Botley West Solar Farm

PINS Ref: EN010147

Document Ref: EN010147/APP/21.7

MASTERPLAN DEVELOPMENT & RATIONALE | JULY 2026

Figure 3 - Central Area Masterplan Changes Animation

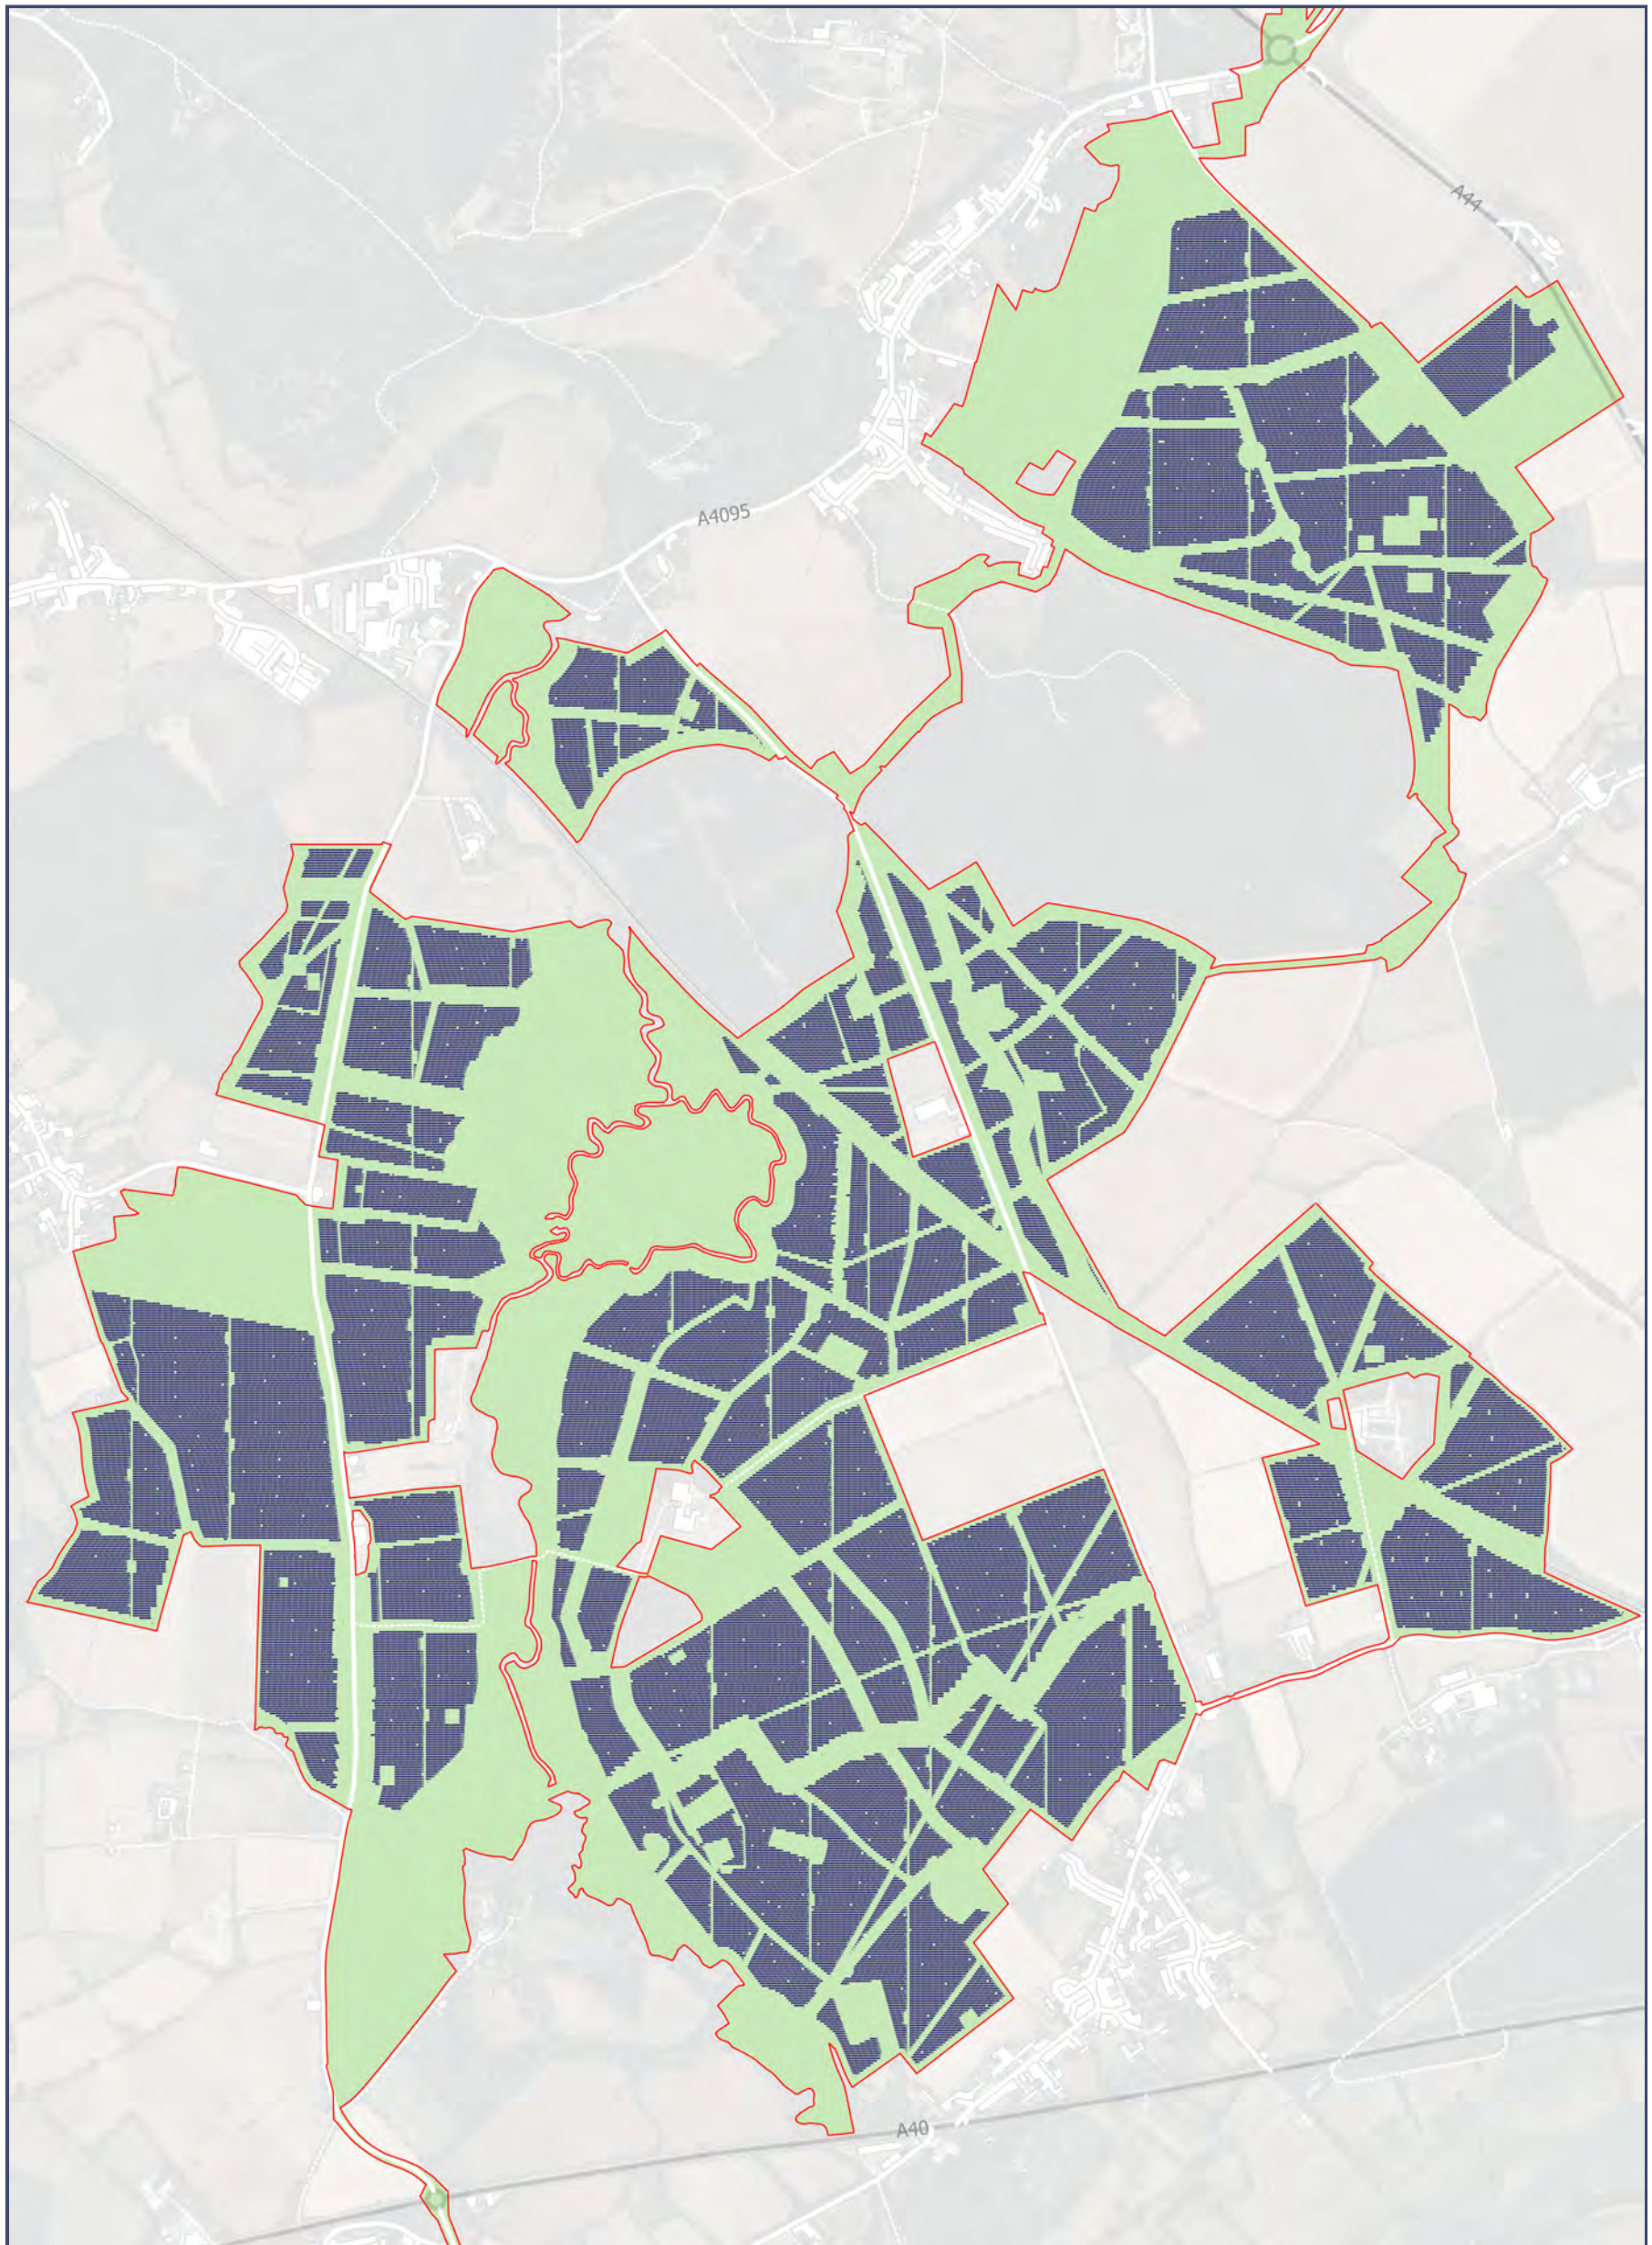
- 3.1
- The central area of the Proposed Development has undergone substantial refinement following the close of the Examination. Building upon the original landscape-led design approach, the revised masterplan responds to additional landscape and visual assessment, further field survey work and continued discussions with the OHA.

- 3.8
- Panels have been selectively removed around:
 - Wolsey Court
 - Campsfield Farmhouse
 - Rose Cottage
 - Heath Lane
 - College Farm
 - Pelican House
 - Owls Leat
 - Willow Cottage
 - Jericho Farm
 - New Barn Cottage
- 3.9
- These interventions increase the physical offset between residential receptors and infrastructure whilst reducing the amount of solar development occupying principal views.
- 3.10
- Rather than applying a blanket exclusion distance across the site, the revised masterplan responds to the orientation, setting and visual relationship of each individual receptor. This approach reflects good design by ensuring that each intervention is proportionate to the sensitivity of the location.

- 3.13
- Panels have been removed from the north eastern parcel to reduce intervisibility between the solar development and properties at Wolsey Court, Campsfield Farmhouse and Rose Cottage.
- 3.14
- The revised layout creates a substantially larger area of undeveloped land adjacent to these receptors, maintaining a stronger perception of openness and reducing the prominence of solar infrastructure in outward views.

- 3.15
- The western edge of the parcel has been pulled back to further reduce the prominence of the solar panels when experienced from Heath Lane.
- 3.16
- Rather than relying on screening vegetation alone, the masterplan has been amended to remove development from the most visually exposed location.

- 3.17
- The revised layout increases separation between the solar development and College Farm and Pelican House through the removal of adjacent panel arrays.
- 3.18
- The retained open land reinforces the existing transition between the residential properties and surrounding agricultural landscape.

- 3.19
- Several targeted removals have been made to preserve the physical and visual separation between the proposed development and these properties.
- 3.20
- The revised layout reduces enclosure, maintains the rural character of the surrounding landscape and reinforces the perception that the properties remain set within open countryside.

- 3.21
- Solar panels have been removed to maintain physical and visual separation between Jericho Farm and the operational development.
- 3.22
- The amendment reduces the perceived scale of development experienced from the property whilst allowing additional landscape enhancement within the retained land.

- 3.26 Panels have been removed to retain the southward appreciation from Burleigh House and Folly Bridge.
- 3.27 The amendment maintains the open foreground which contributes to the rural setting of these receptors.

3.28 Development has been pulled back to preserve eastward views from Burleigh Farm. The retained open land strengthens the transition between the farmstead and surrounding countryside.

3.29 Panel removal maintains northern and eastern outlooks from Goose Eye Farm and reinforces the openness of the surrounding landscape.

3.30 Additional undeveloped land has been retained north of Barrow Court, Yarnton Road, Elms Road, Williams Court and Eynsham Road to preserve the open rural setting of these residential areas.

- 3.45 Panels have been removed to retain an open southward appreciation across Bladon Heath from the existing Public Right of Way.
- 3.46 Rather than enclosing the route with solar panels and supporting infrastructure, the revised masterplan retains a broader landscape corridor, which better reflects the existing experience of moving through open countryside.

Figure 4 - Southern Area Masterplan Changes Animation

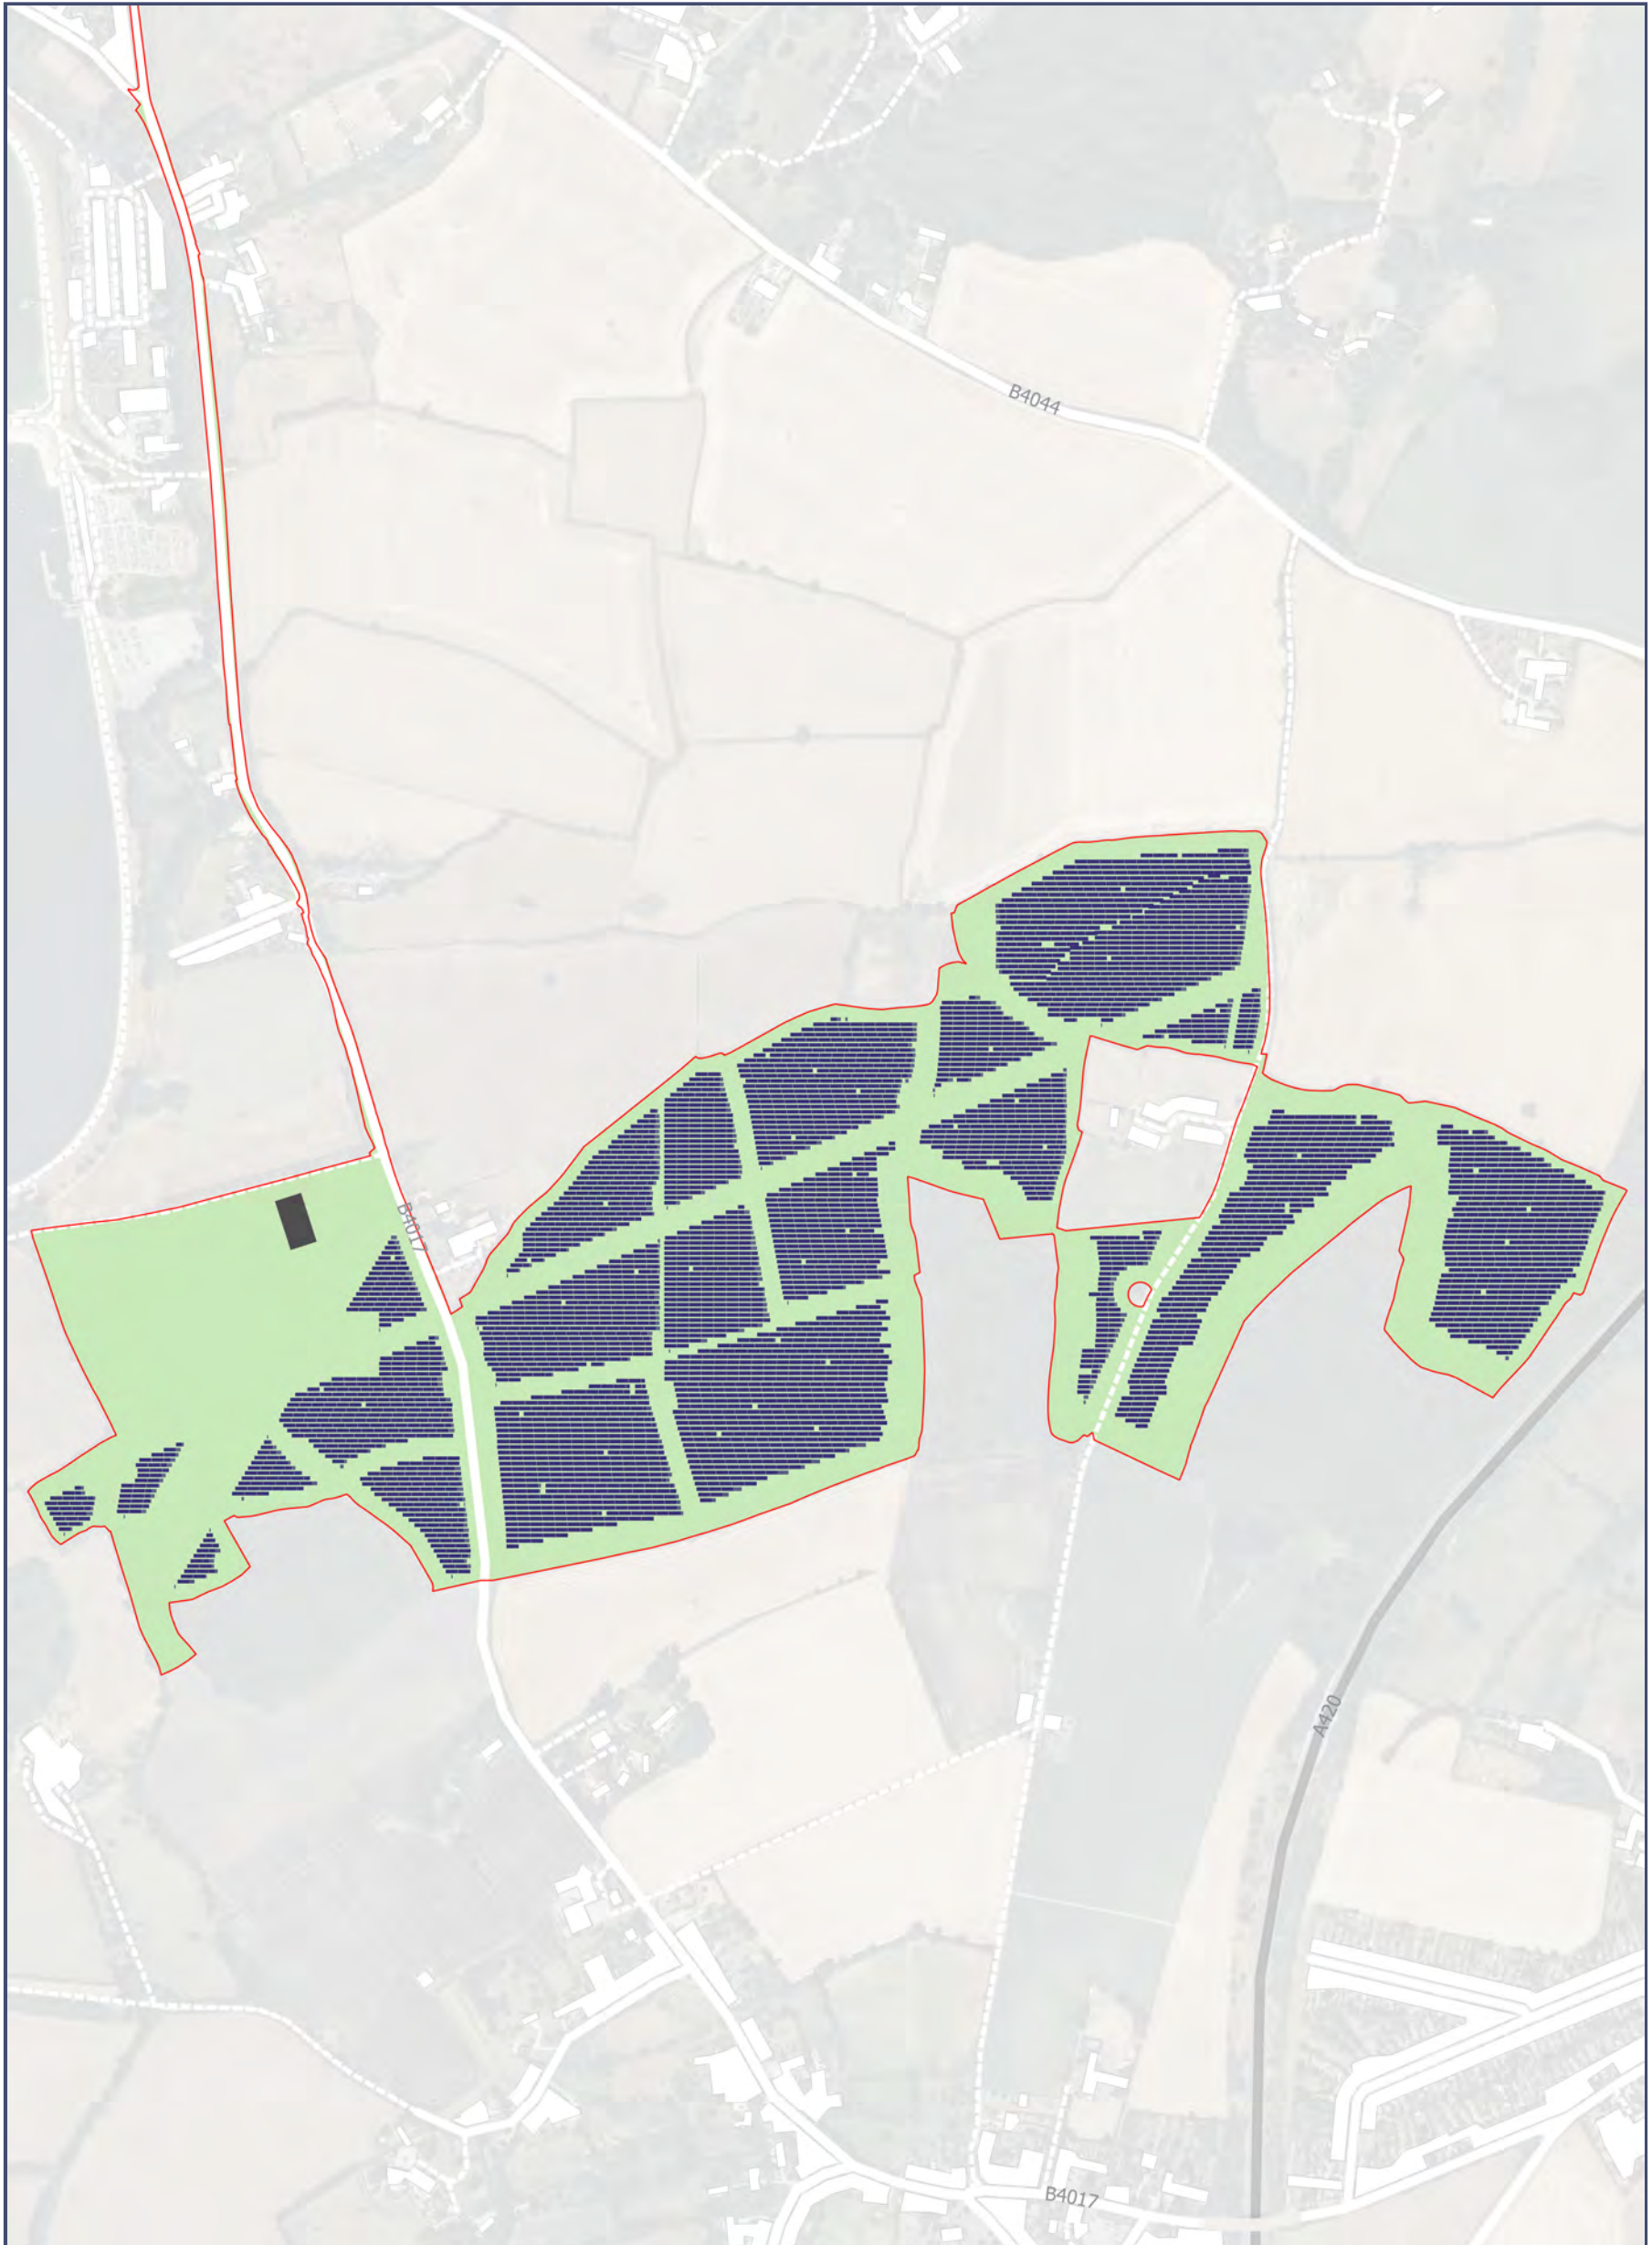
- 4.1
- The southern area of the masterplan has undergone a series of targeted design refinements following the close of the Examination in response to further landscape and visual assessment, additional site survey work and ongoing consultation with the Oxfordshire Host Authorities (OHA).

- 4.2
- The amendments focus principally on strengthening the relationship between the solar development and the surrounding rural landscape through increased physical and visual separation from nearby residential receptors and the retention of a greater sense of openness along the western edge of the site. In addition, the relocation of the proposed substation has enabled a more sensitive arrangement of infrastructure that better responds to the surrounding landscape and views from nearby receptors.

Relocation of the Proposed Substation and Western Panel Removal

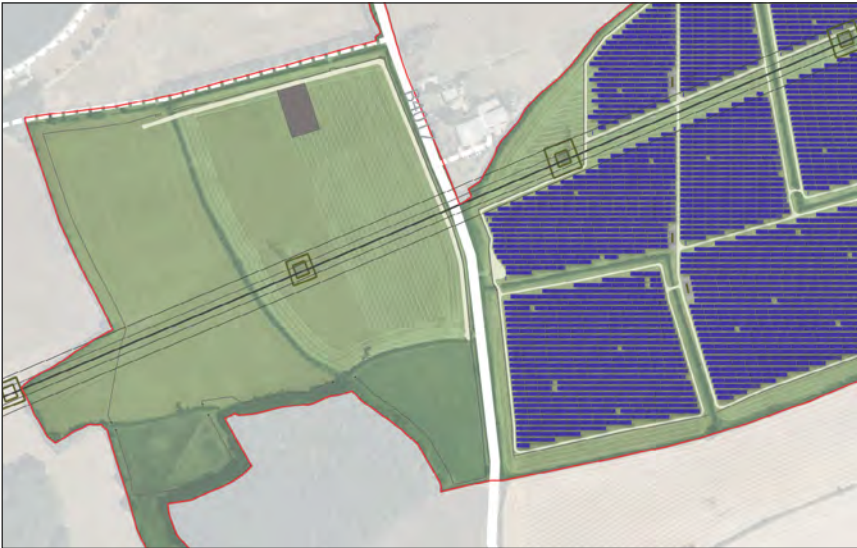
- 4.5
- The most significant amendment within the southern area has been the removal of solar panels from the western part of the development parcel together with the potential relocation of the proposed substation further to the west.

- 4.6
- This refinement has been undertaken to retain the sense of openness along the western side of the B4017, increase visual separation from Jumpers Farm and reduce the potential for views of the operational infrastructure from Upper Whitley Farm.

- 4.7
- The revised arrangement the large area of undeveloped land between the highway, nearby residential receptors and the solar development. This not only preserves the perception of openness that characterises this part of the landscape but also provides greater flexibility for landscape enhancement and habitat creation.

- 4.8
- Potentially relocating the substation as part of this redesign ensures that associated infrastructure sits within a more appropriate landscape context whilst continuing to satisfy the operational requirements of the solar farm.

Strengthening Separation from Jumpers Farm

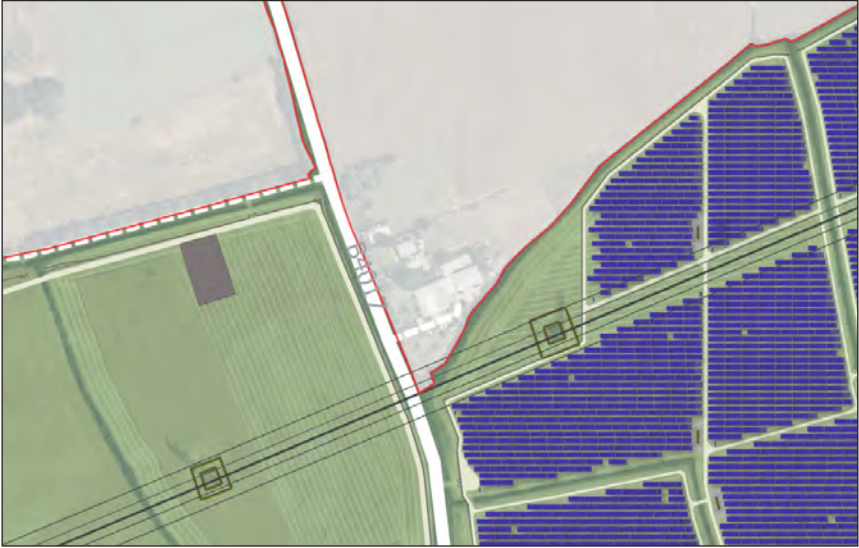
- 4.12
- Panels have been removed from immediately adjacent to Jumpers Farm to strengthen the physical and visual separation between the property and the solar development.
- 4.13
- The revised layout preserves the property's immediate rural setting by increasing the extent of undeveloped land surrounding the farmstead and reducing the influence of development infrastructure within its outlook. The retained land also creates opportunities for landscape enhancement that further reinforces the transition between the existing built environment and the surrounding agricultural landscape.

Increasing Separation from Green Belt Way

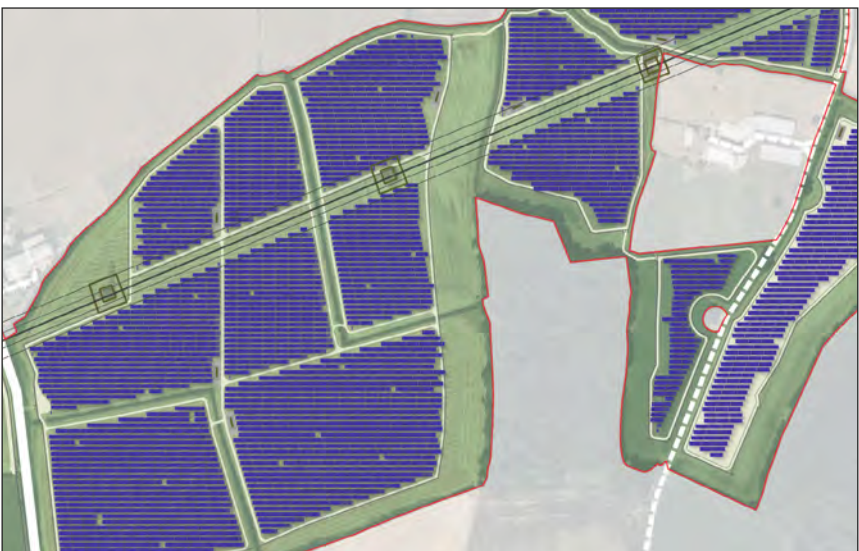
- 4.15
- Solar panels have been removed to increase the separation between the solar development and Green Belt Way, thereby preserving the open character experienced along this route and maintaining a greater sense of openness within the surrounding landscape.
- 4.16
- The amendment widens the undeveloped corridor adjacent to the route, reducing the perceived scale of development and ensuring that operational infrastructure does not dominate the immediate landscape setting.

- 4.17 The retained land also contributes to the wider landscape framework by providing opportunities for habitat creation and strengthening ecological connectivity.
